STAFF RECOMMENDATION
208-210 Broadway
October 19, 2016

Application: New construction-addition, Alterations
District: Broadway Historic Preservation Zoning Overlay
Council District: 19
Map and Parcel Number: 09306211100
Applicant: Kristy Angyal/ Kip A. Moore & Associates
Project Lead: Robin Zeigler, robin.zeigler@nashville.gov

<p>Description of Project: The project is for rehabilitation of two contributing buildings and a rooftop addition on one of the buildings.</p>	<p>Attachments A: Photographs B: Site Plan C: Elevations</p>
<p>Recommendation Summary: Staff recommends disapproval finding that the project does not meet section II.of the design guidelines for alterations to historic buildings.</p>

PROPOSED SOUTH ELEVATION

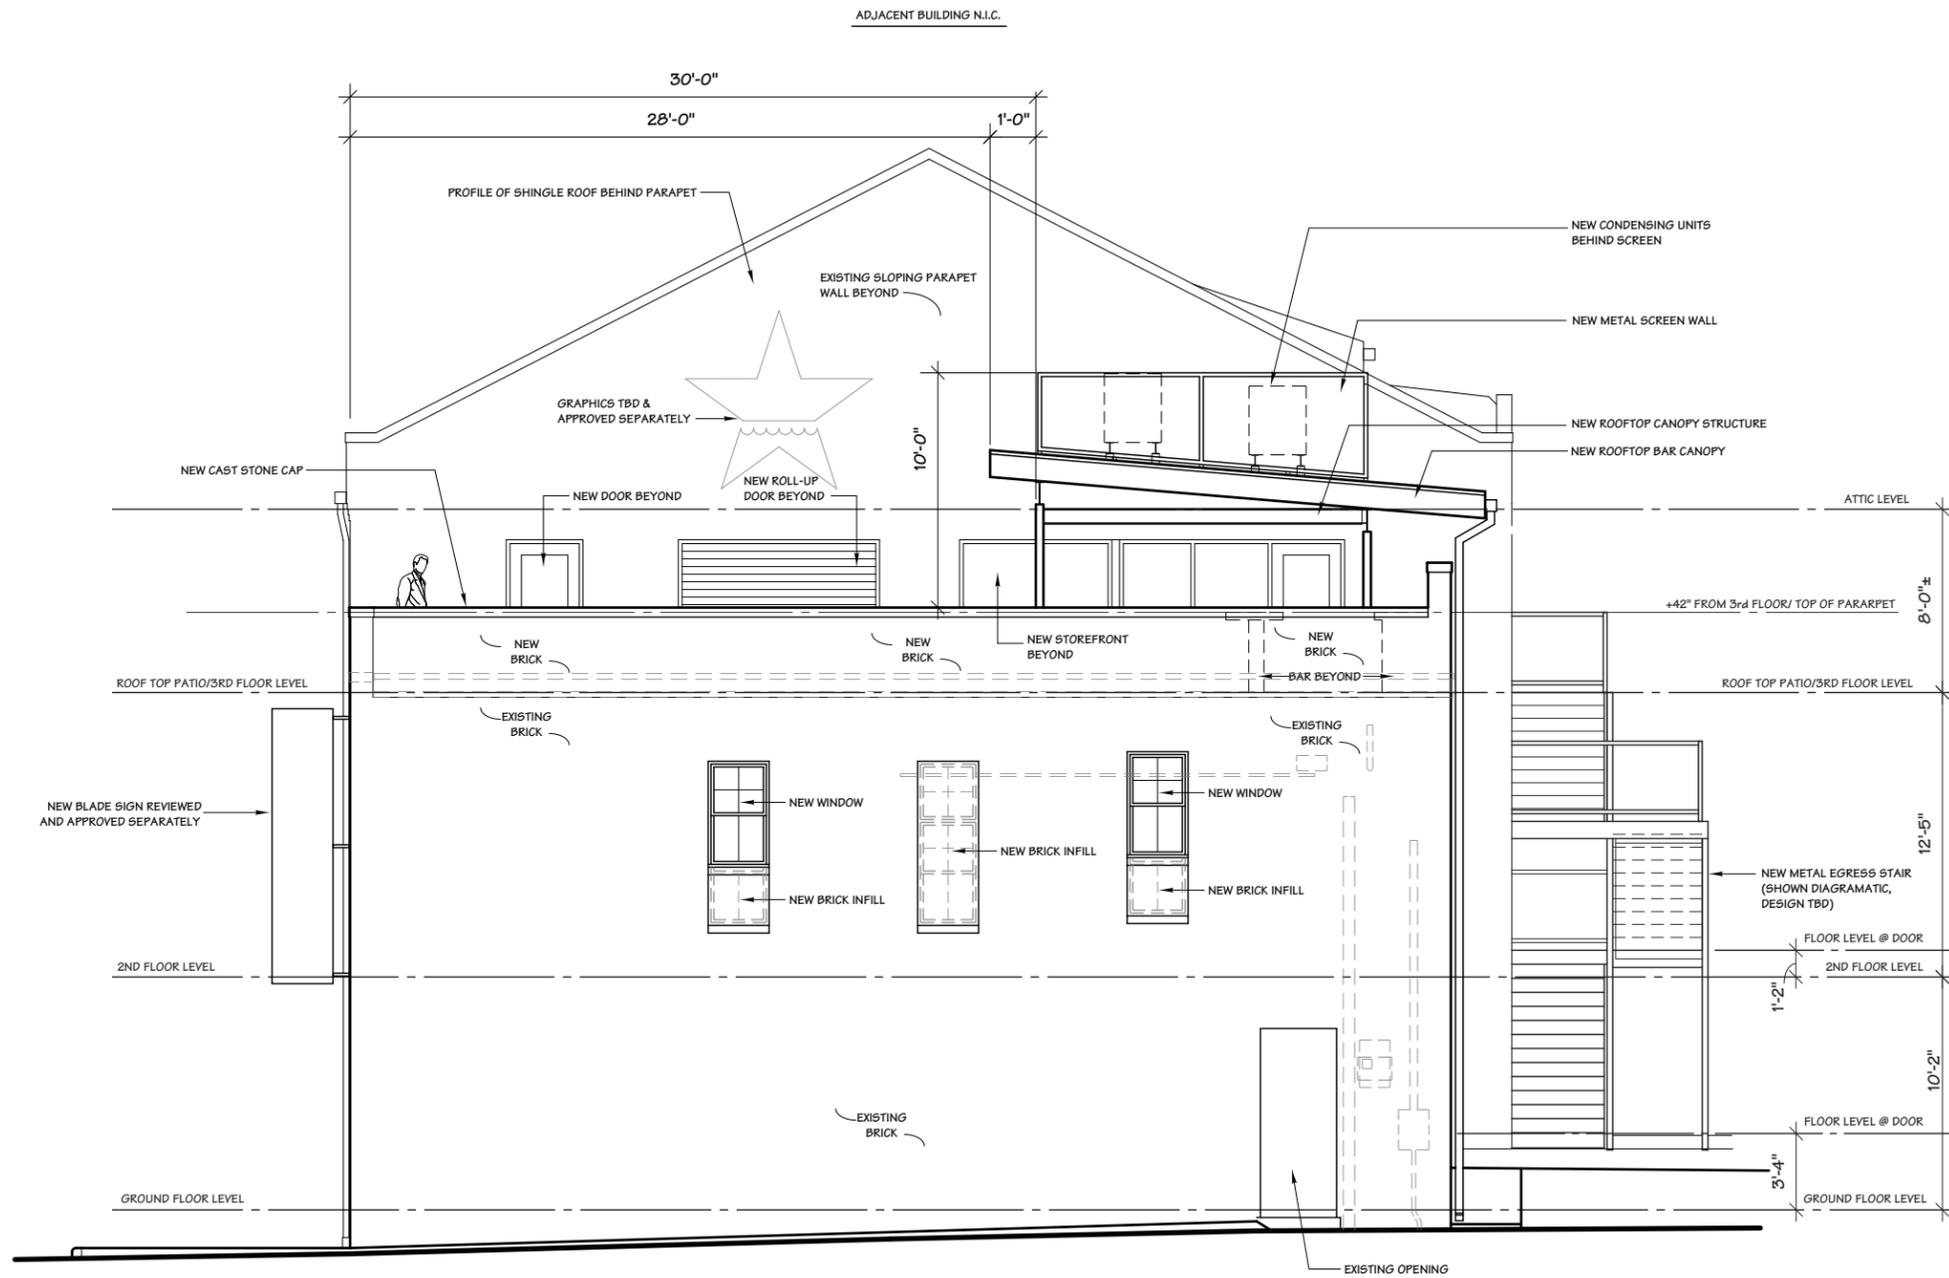
210 Broadway will have a recessed entrance, similar to many that are seen historically on Broadway with transoms above, paneled bulkhead below and secondary entrance to the left. One area that should be a clear-glazed storefront will be an opaque fixed window because of the moved 2nd level floor. Staff finds this to be inappropriate, as it does not meet section II. General Principles for Facades.

The proposed storefront façade for 208 Broadway is stepped back to be behind two support posts that are currently interior elements, located to each side of the central entrance. The proposal also includes NANA walls and a non-operable door. Although storefronts historically do sit back a few inches from the brick façade, the proposed does not meet the design guidelines as the structural supports are exposed. The NANA wall should be seamless in a two-window storefront type configuration to meet section II C. for storefronts. In addition, the entrance does not appear as a principle entrance, which does not meet section II.B of the design guidelines.

Upper levels: There are no proposed changes for the front, upper level of 210 Broadway. The existing shingle roof, brick and windows will all remain. New openings will be cut into the right, upper-level elevation including doors, windows and roll-up doors. Staff finds this to be appropriate since this elevation does not include character defining features, and although visible, do not affect the primary look and character of the building. The project meets section II.H and I.

- 1. Provide a scope of work explaining how the building will be stabilized during construction, an engineer report confirming that the buildings' structural integrity will not be compromised with this alteration;*
- 2. Recommends moving floors so that they do not obstruct openings;*
- 3. Provide additional information on materials: masonry, all windows and doors, rooftop addition and the frosting of opaque glass; and,*
- 4. Propose a new storefront design to address the NANA walls, a primary entrance design, and the support posts.*

PROPOSED
EAST (ALLEY) ELEVATION 1/8" = 1' - 0"

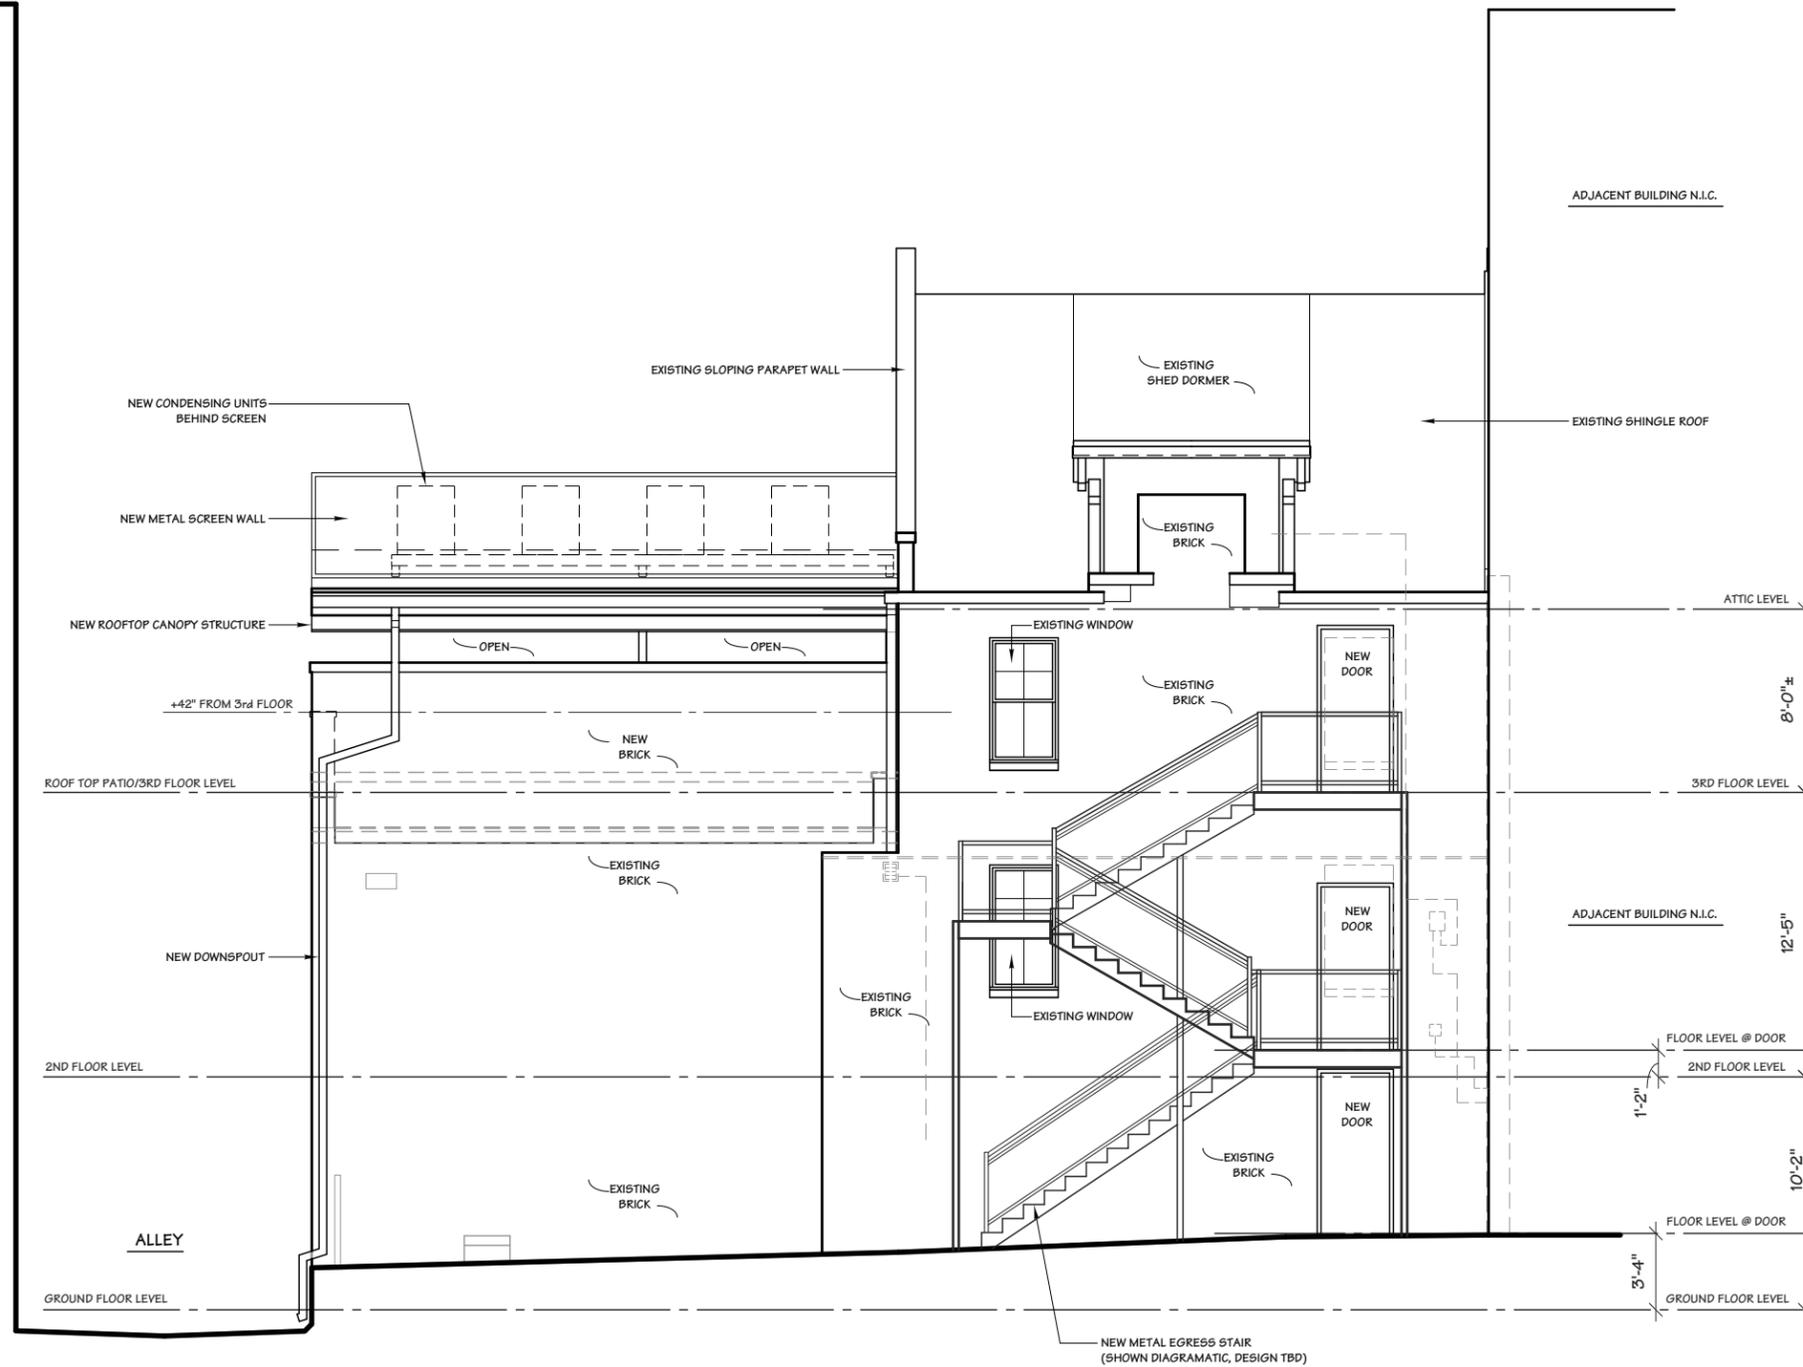
The right side, upper level of 208 Broadway faces an alley. Two existing windows will be altered in dimension and one will be enclosed. Staff finds this to be appropriate since this elevation is not a public façade and the windows are not character defining features. The front, right side, and rear walls of 208 Broadway will increase by approximately three-feet (3') to create a parapet wall and include one-inch (1") recessed panels with sills matching the windows below on the front. Since this building used to be three-stories and parapet walls are a common roof form in the district, staff finds the alteration to meet the design guidelines. It is not known if an exact match to the existing brick is possible; however, a variation in brick will show how the building has changed over time and distinguish new from old. With staff's approval of brick and stone, the project meets design guideline II.I and II.L.5.

PROPOSED
NORTH ELEVATION

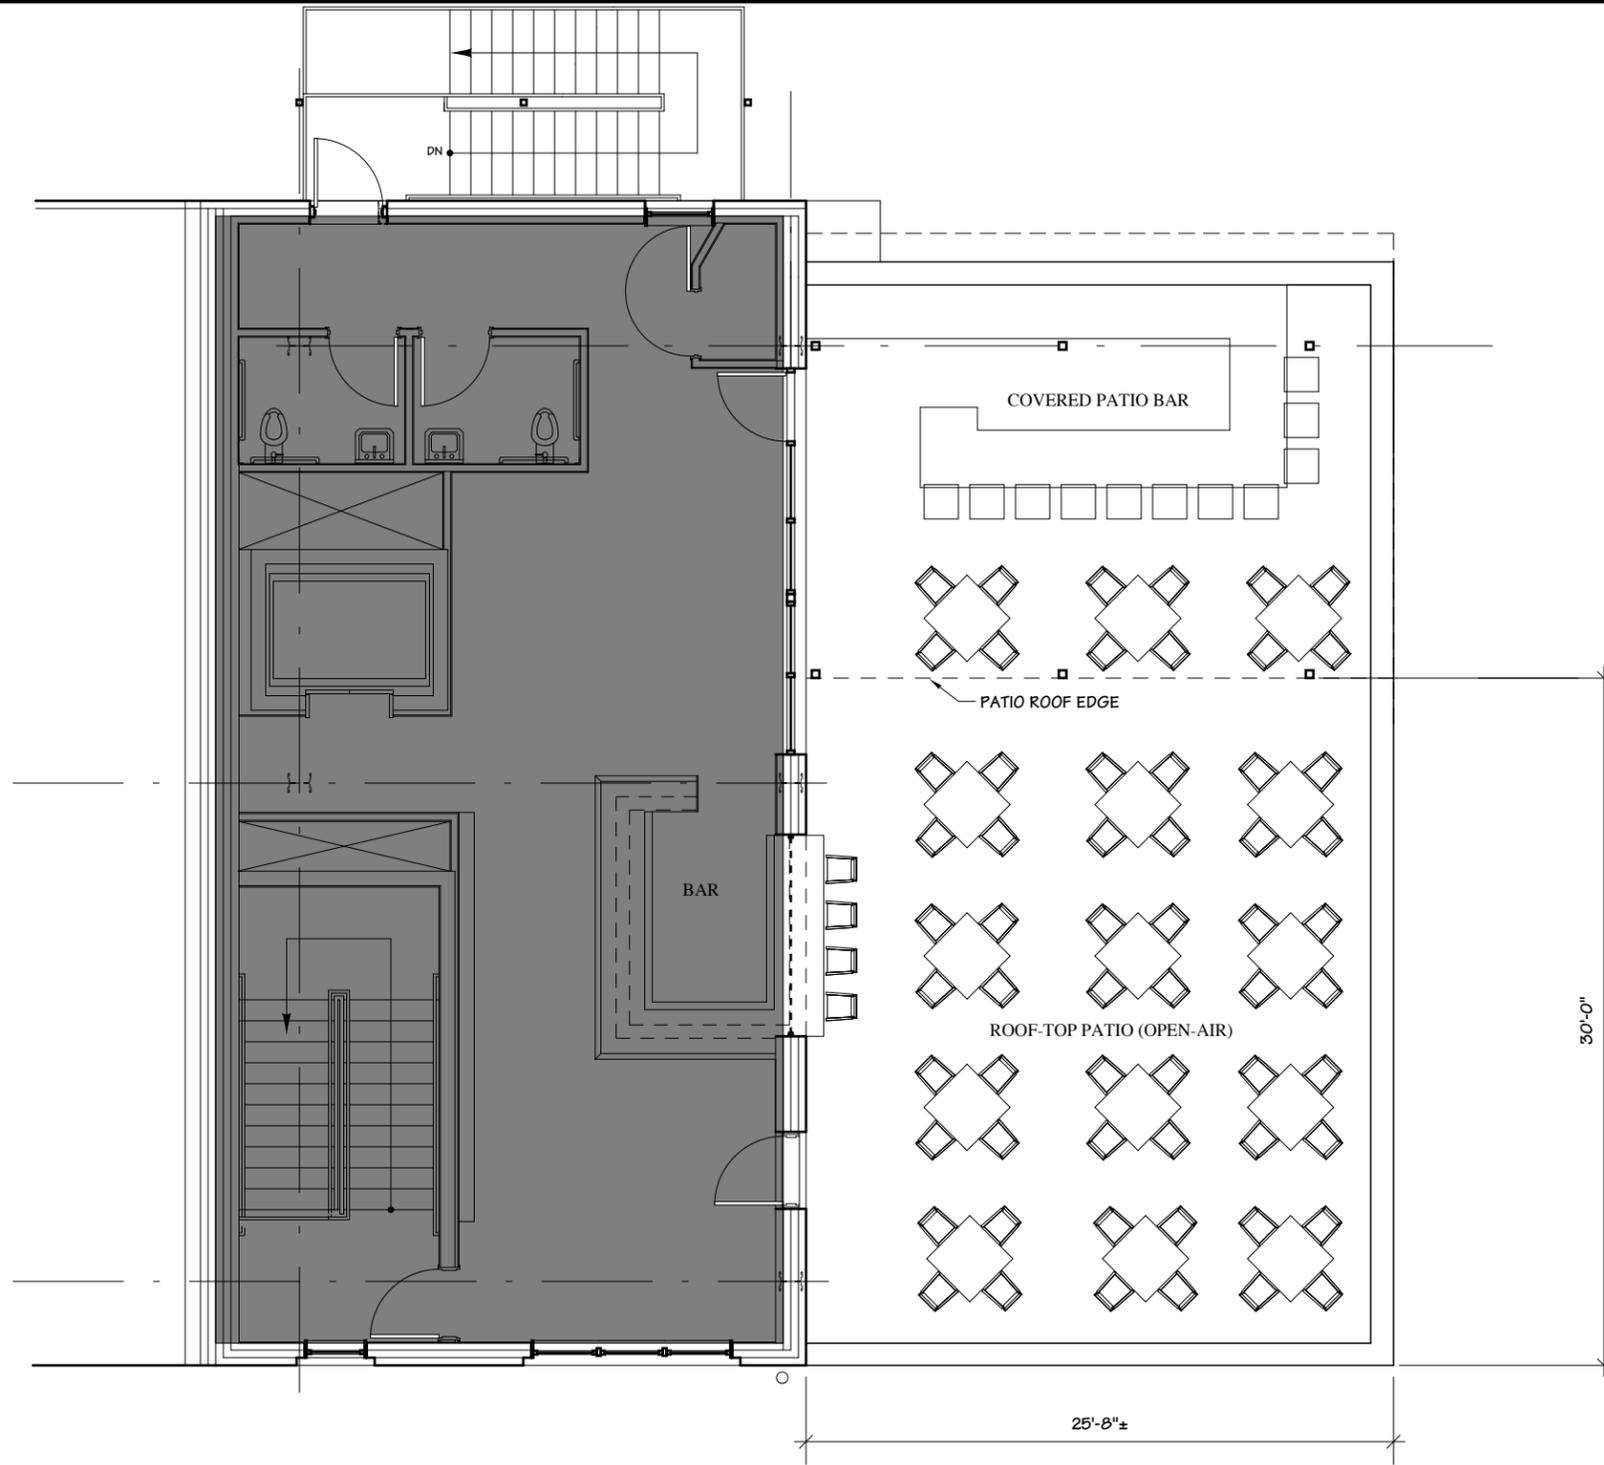
Rear façade: A metal staircase will be added to the rear façade which meets section II.N.3 and II.Q

PROPOSED
ROOF-TOP PATIO PLAN

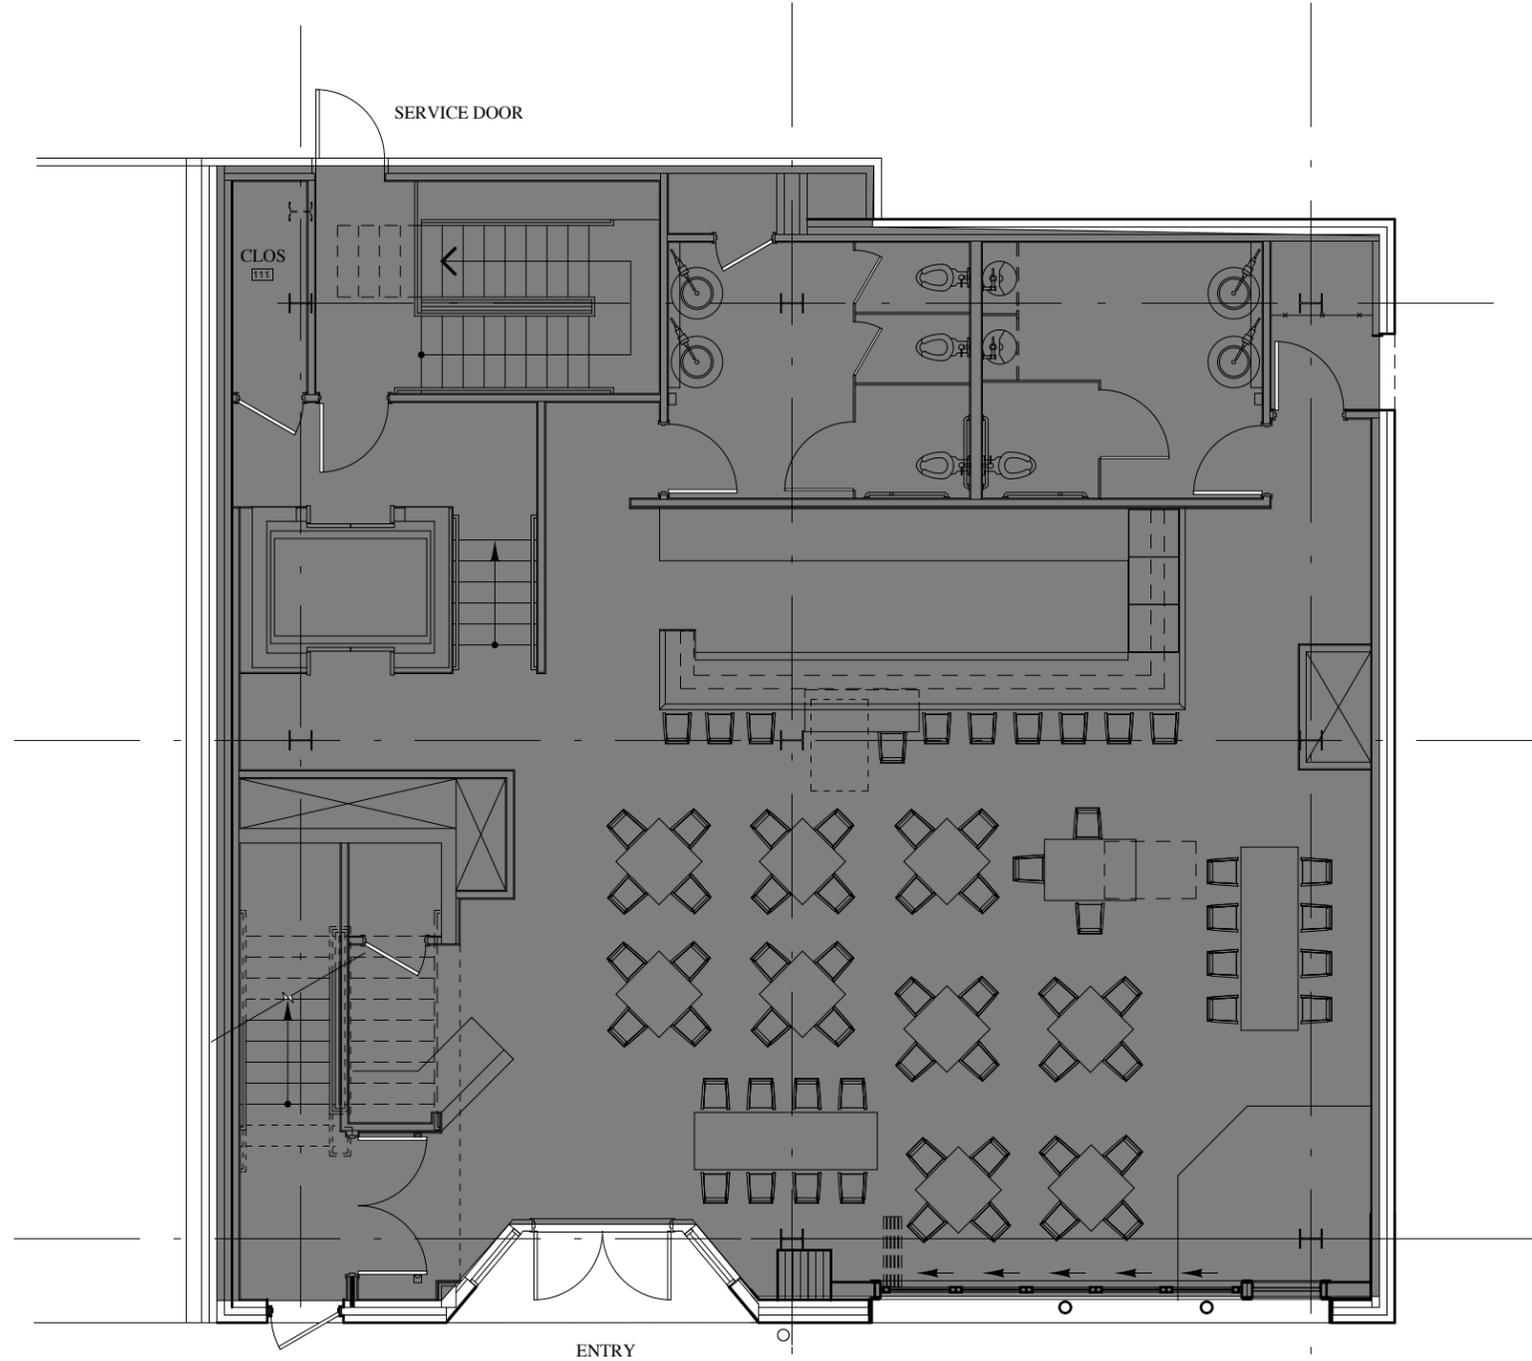
Mechanicals: Mechanicals will be located on the rooftop addition of 208 Broadway and screened. Since the addition meets the height requirements, this is an appropriate location for mechanicals and meets Section II. L.

Rooftop Addition: The covered portion of the rooftop addition will be approximately thirteen feet (13') from the top of the new parapet wall and stepback the required thirty feet (30'). A side stepback is not required since this is not a corner lot. A railing is not required since the parapet wall will serve the same function. The only items to be located in the stepback area are non-permanent tables and chairs. The addition itself is a shed roof structure without sides and metal screen on top for mechanicals. The project meets section III.H.
